Modifications Notices

No. 2020128AE(ON)

Modification Notice of change for expiration date of Moisture-proof packaging due to change in weight of desiccant for G3VM MOS FET relay.

G3VM Series

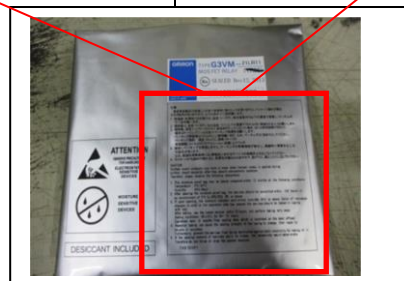
To improve quality

Before the change	After the change
<p>1. Note on Moisture proof packaging</p> <p>Expiration date of Moisture-proof package : 12 months</p> <p>(Note Details)</p> <p>(1) This moisture proof bag may be stored unopened within <u>12 months</u> at the following conditions. Temperature : 5 deg C to 30 deg C Humidity : 90 % (Max.)</p> <p>(2) Expiration date: <u>12 months</u> from sealing date, which is imprinted on the label affixed.</p>	<p>1. Note on Moisture proof packaging</p> <p>Expiration date of Moisture-proof package : 24 months</p> <p>(Note Details)</p> <p>(1) This moisture proof bag may be stored unopened within <u>24 months</u> at the following conditions. Temperature : 5 deg C to 30 deg C Humidity : 90 % (Max.)</p> <p>(2) Expiration date: <u>24 months</u> from sealing date, which is imprinted on the label affixed.</p>
<p>2. Weight of desiccant (including moisture proof Bag)</p> <p>10 g</p>	<p>2. Weight of desiccant (including moisture-proof Bag)</p> <p>20 g</p>
